SANITARY SEWER LAY OUT
LANKIN ADDITION
Wichita, Kansas
R.S. DELAMATER
CONSULTING ENGINEER
WICHITA, KANSAS

January 6, 1970

We are handing you herewith the tracings for the 48" storm sewer and the sanitary sewer which have been constructed to serve the Lankin Addition.

48" Storm Sewer Layout
Lankin Addition
May, 1969
R.S. Delamater
Consulting Engineer
Wichita, Kansas

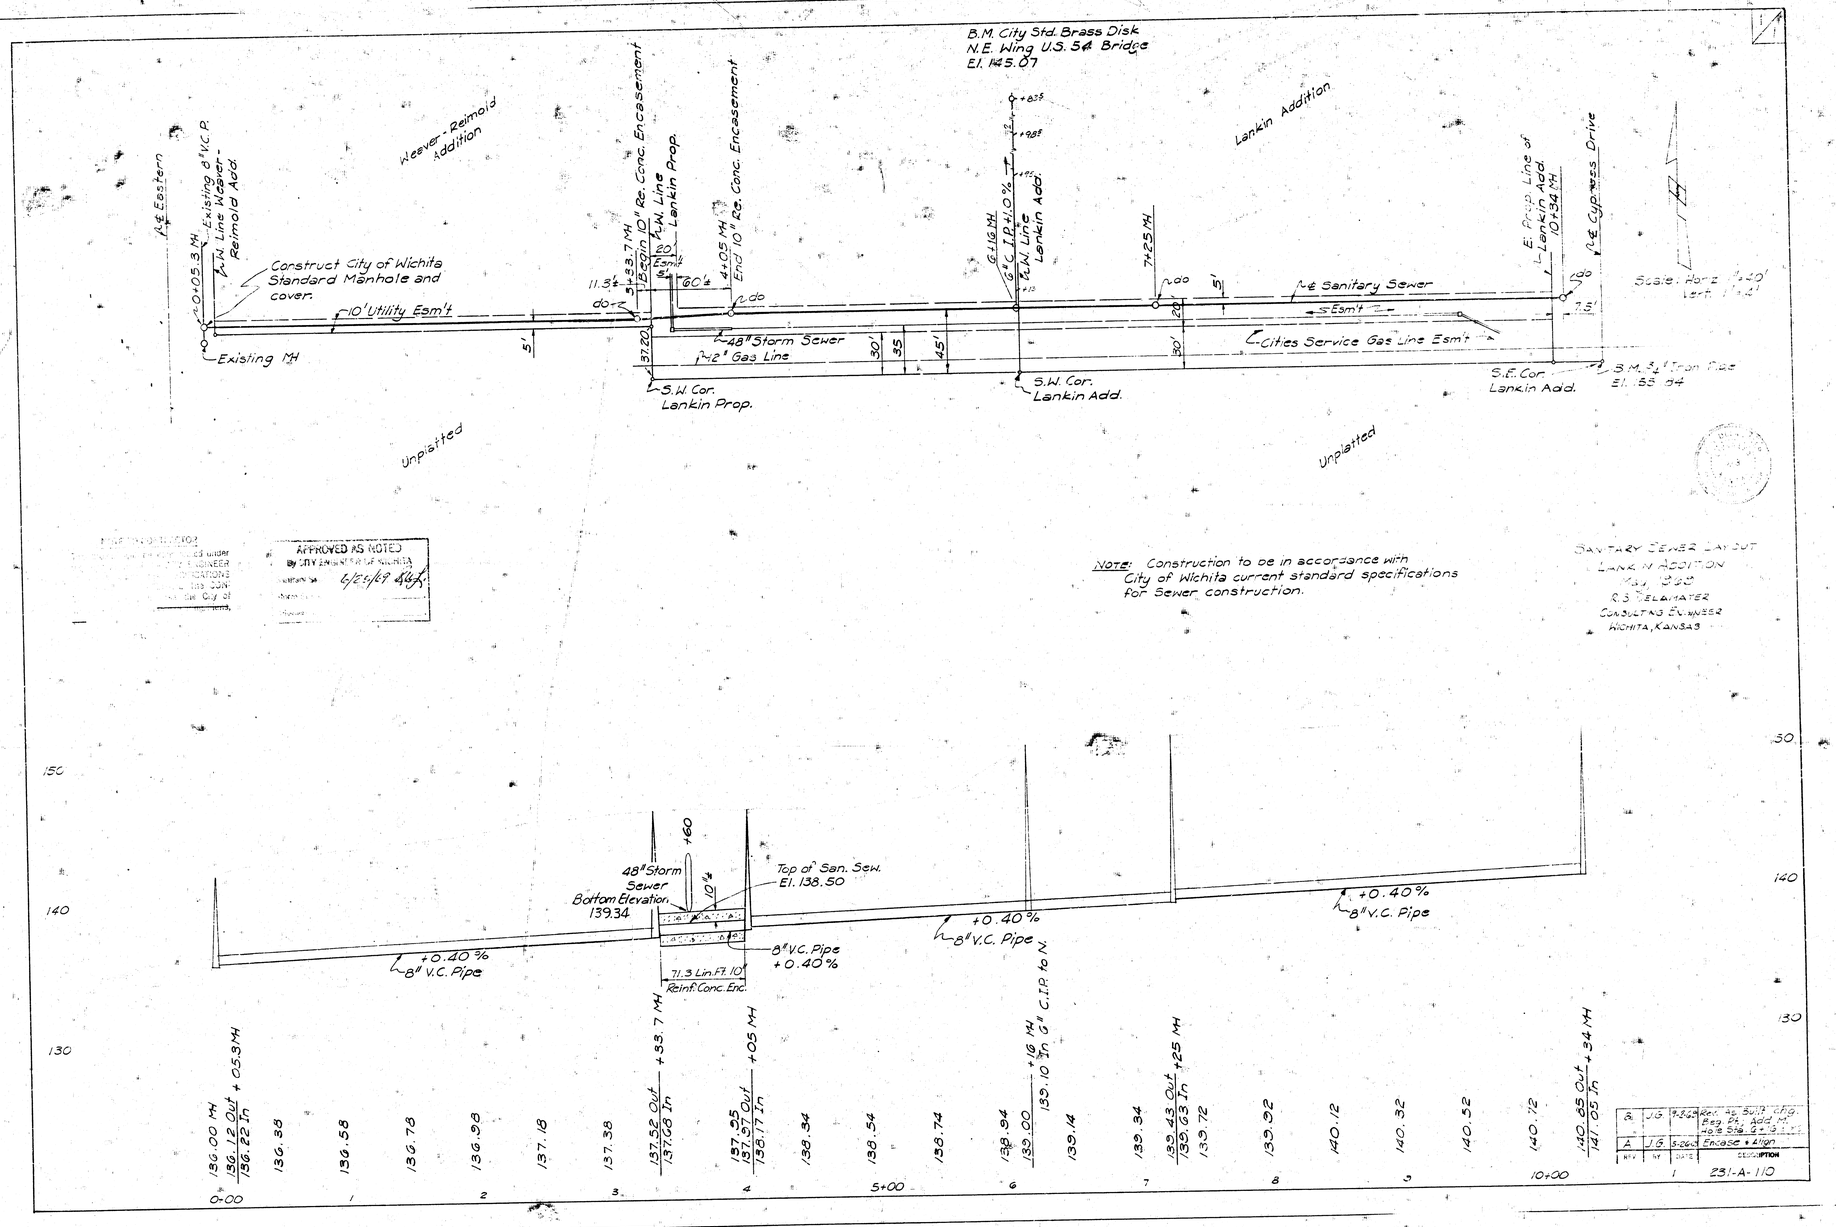
These tracings have been corrected to indicate the grades and dimensions as built and also to include the connecting lines into the sewers; in the case of the storm sewer we have indicated the location, flowline and grate elevation of the inlets which discharge into the manhole at the eastern end of the line.

NOTE, As built: All concrete manholes are built with standard concrete bottom sections, and brick extensions, with 2' square grate tops.

~~Bott. 12" Gas Line El. 149.77~~ 149.36 In (Lowered to below 48" Storm Sewer)

Note: As built revisions 12.5-69 are to show changes in the fields by others, and do not reflect changes in the plans by the consultant.

REV.	BY	DATE	DESCRIPTION
C	J.G.	11-5-69	Revised as Built
B	J.G.	6-12-69	R.C.S.P. on ℄ Inlets at E. In and Out
A	J.G.	5-12-69	60" R.C.P. to 48" Add Inlet
